DESIGN REVIEW BOARD – URBAN DESIGN PANEL AGENDA

Regular Meeting
May 7, 2020
4:00 PM
Webex Virtual Meeting

**Planning Staff Report to
Design Review Board - Urban
May 1, 2020**
for the May 7, 2020 Public Hearing

COURT YARD FLOOR PLAN

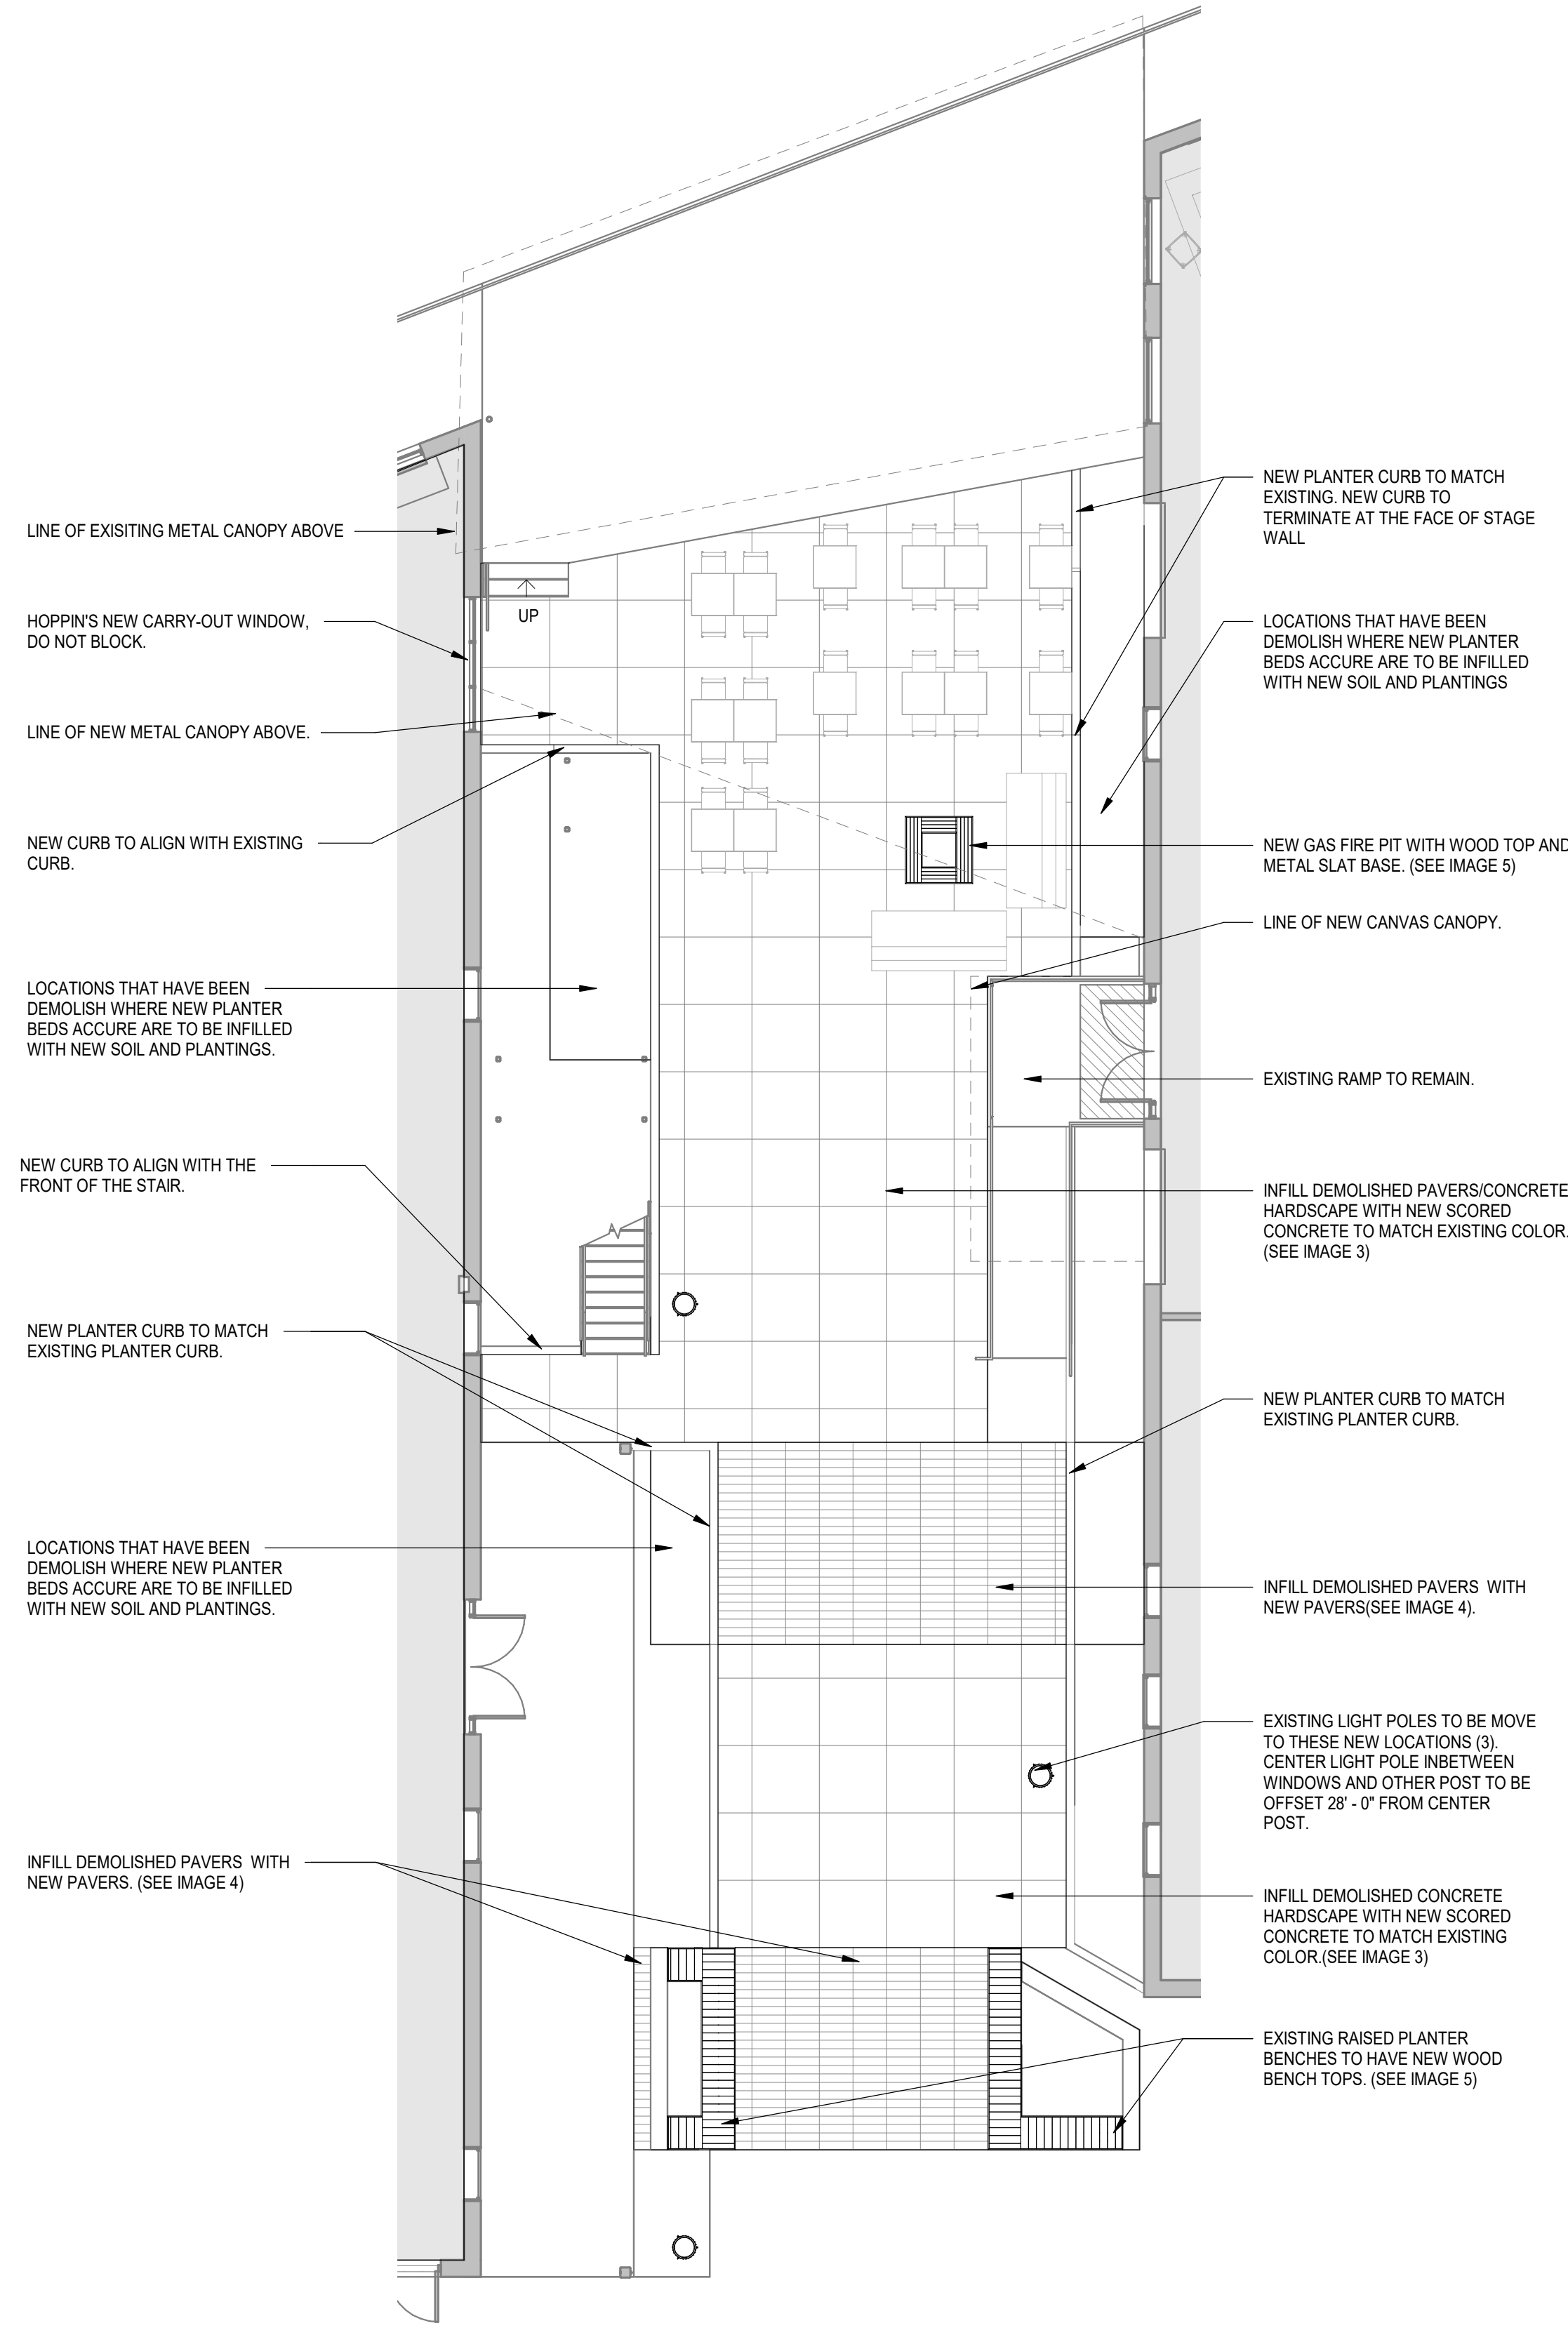
The applicant proposes to renovate the existing courtyard at Markley Station at 116 N. Markley St. Proposed modifications include:

- Construct a canopy extension to match the existing canopy over the stage area;
- Demolish 4 of the 6 existing raised planter benches; the 2 benches closest to Markley St. are to remain; and
- Replace the existing concrete pavement with new scored concrete and pavers.

In addition to the canopy addition, the applicant proposes to remove four existing raised planter benches to provide additional room for outdoor seating. Two planter benches near the courtyard entrance will remain and be refurbished with new wood bench tops.

The applicant also proposes to replace the existing concrete pavement with new scored pavement and linear pavers.

Staff believes the proposed modifications to the courtyard are compatible with the previous approvals for Markley Station and are consistent with the pertinent downtown design guidelines. Therefore, staff recommends approval with the following condition:

- 1) Submit a final landscape plan to staff for review.
-

LARGE CANOPY TREE (40'-60' HT.)
WILLOW OAK
BALD CYPRESS
SWAMP WHITE OAK

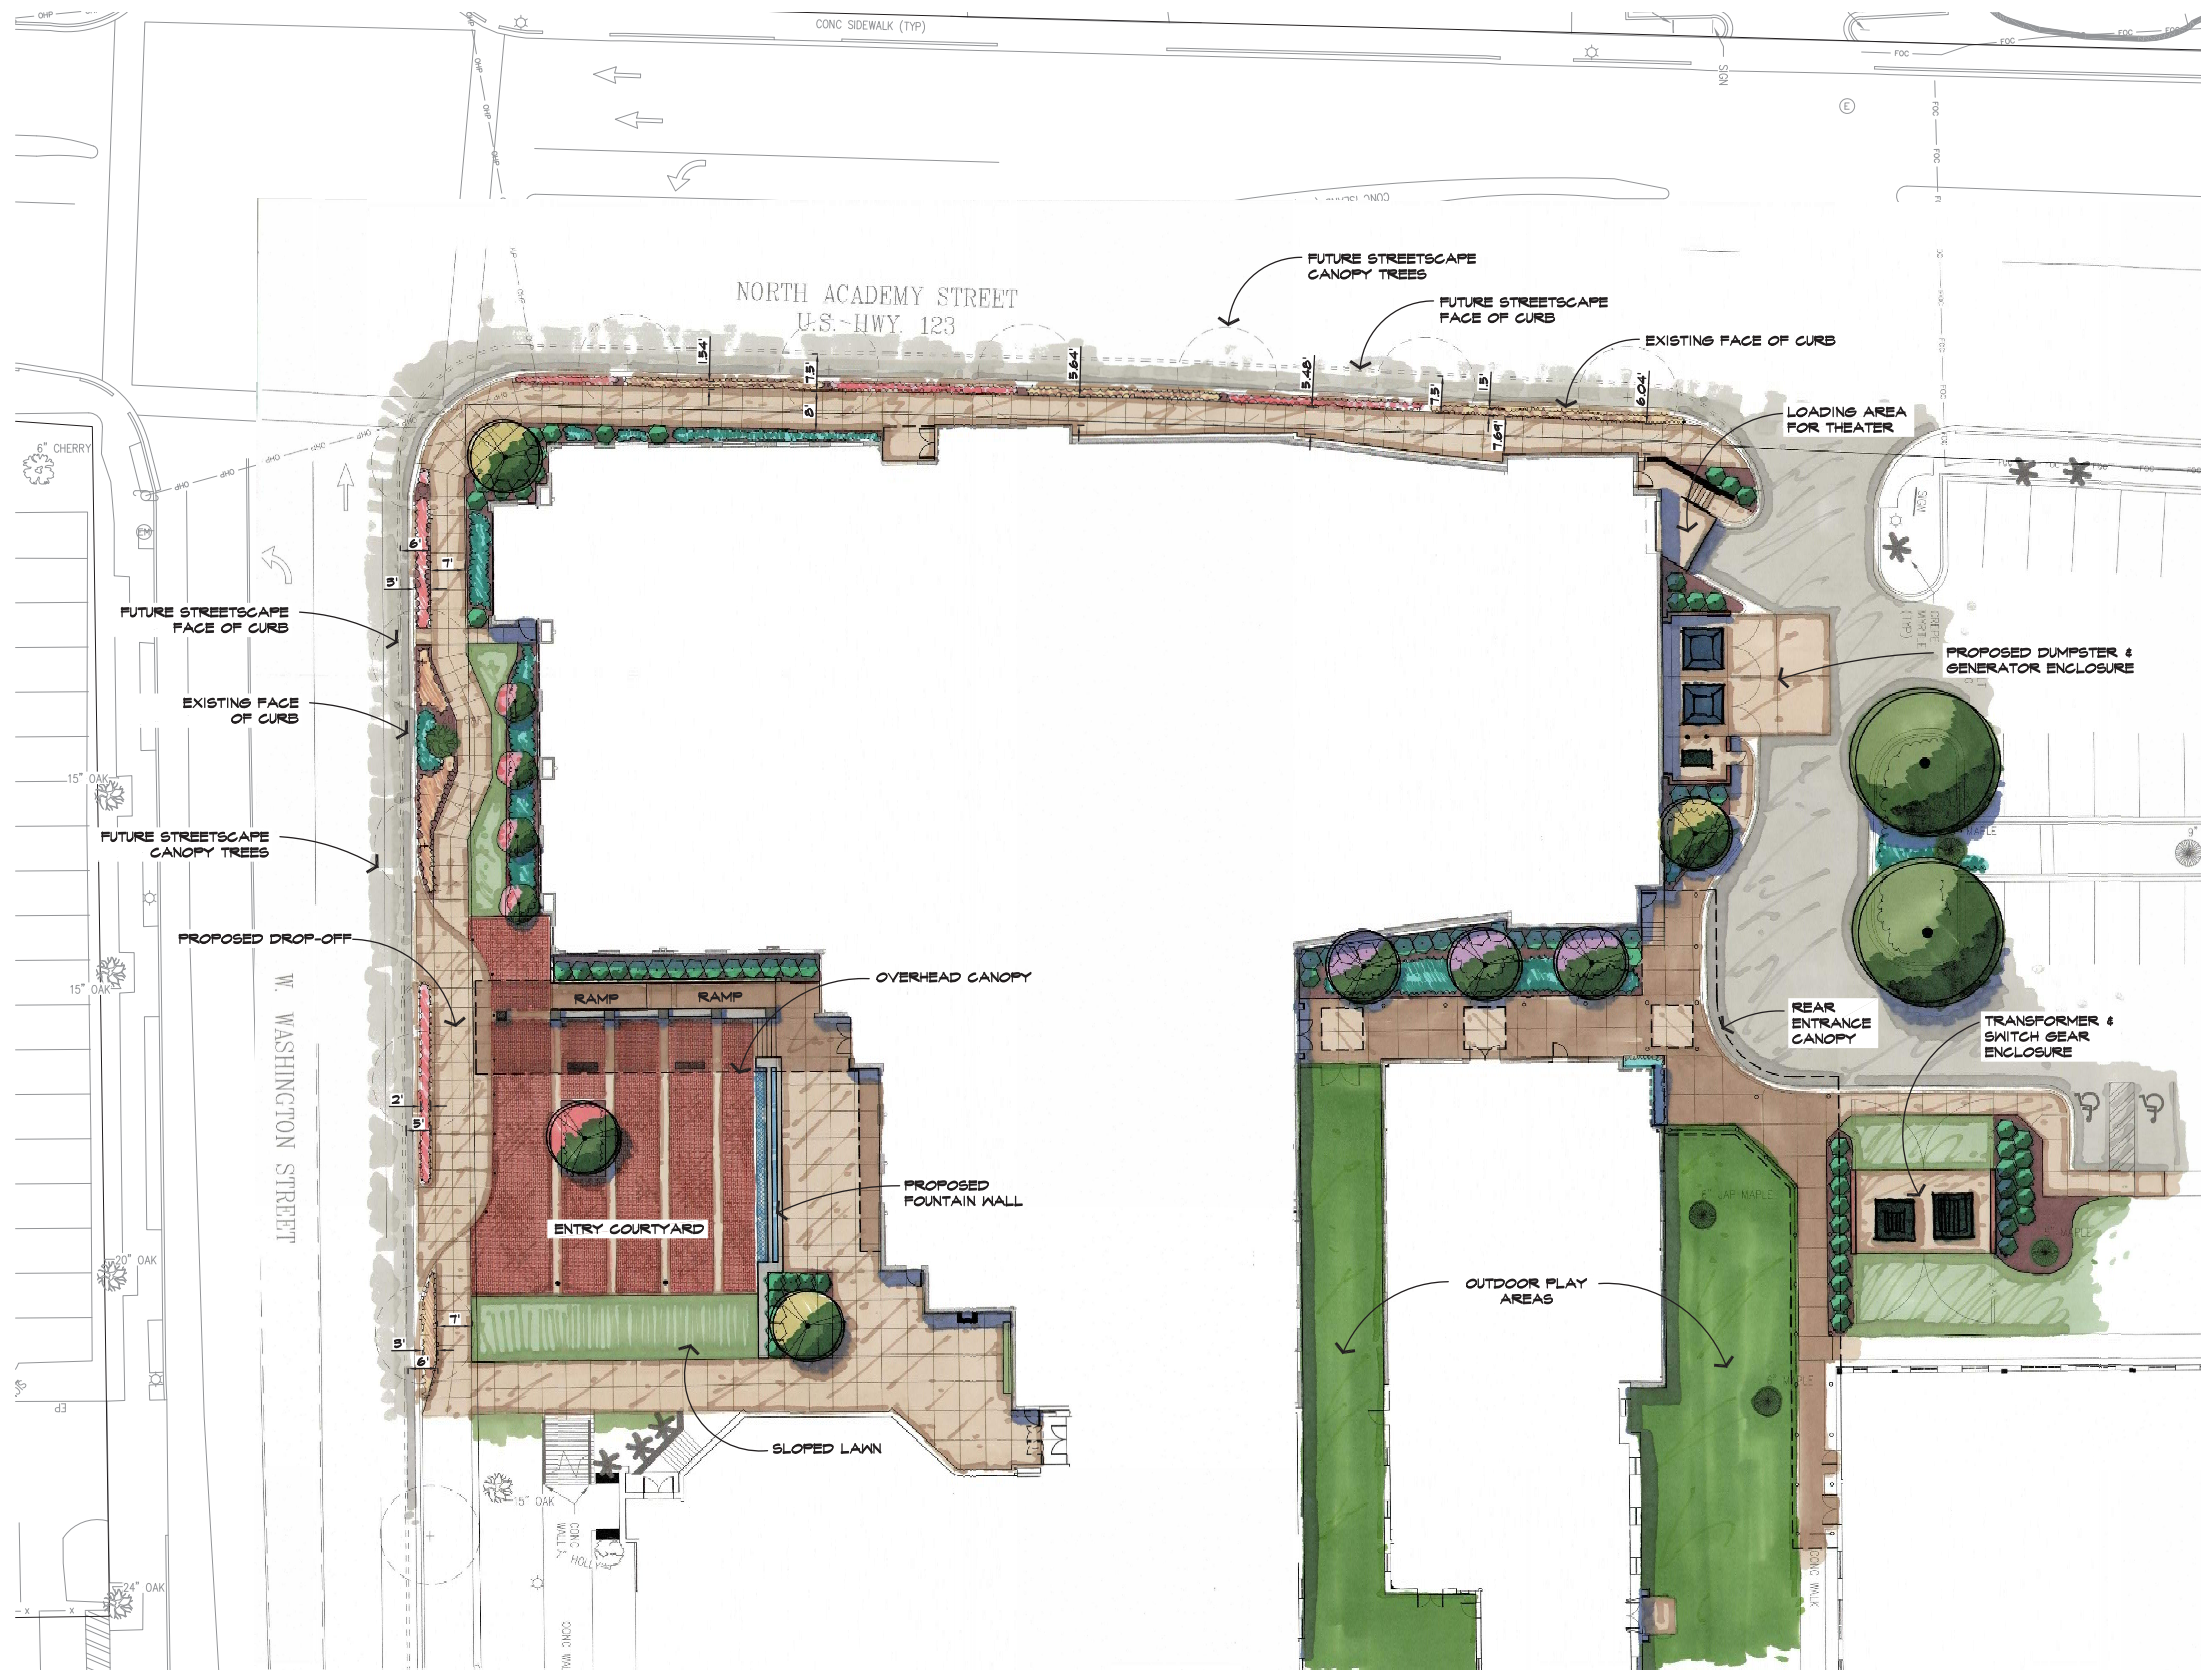
The applicant has submitted two Landscape Plans – one labeled “proposed” and one labeled “with city expansion.” The “city expansion” plan appears to include an additional 5.5 ft. -wide planting strip within the Academy St. right-of-way. During staff and departmental review of the project plans, it was noted that the city currently does not have definitive plans to install street trees along N. Academy St. or W. Washington St. The Parks and Recreation Dept. notes:

The landscape plan shows the required street trees being postponed to some future time. This does not meet the requirements of the ordinance, and may require shifting the site plan to allow the street tree requirement to be met. Street trees are to be planted on private property, with a spacing of 1 canopy tree for every 40 feet if no powerlines are present, and one understory/ornamental tree for every 20 feet if powerlines are present.

1. Modify the plans, as needed to comply with Land Management Ordinance requirements, to increase the width of the pedestrian realm along N. Academy St. The pedestrian realm includes the building transition, sidewalk, and street furnishing zones.
2. Incorporate the required street trees along W. Washington St. and N. Academy St.
3. Increase building articulation, transparency, and ground-floor activation along the N. Academy St. façade. Large blank wall areas do not comply with requirements.
4. Submit a more detailed courtyard amenities plan which shall contain specifications of amenities to include the water feature, pedestrian seating, and lighting.
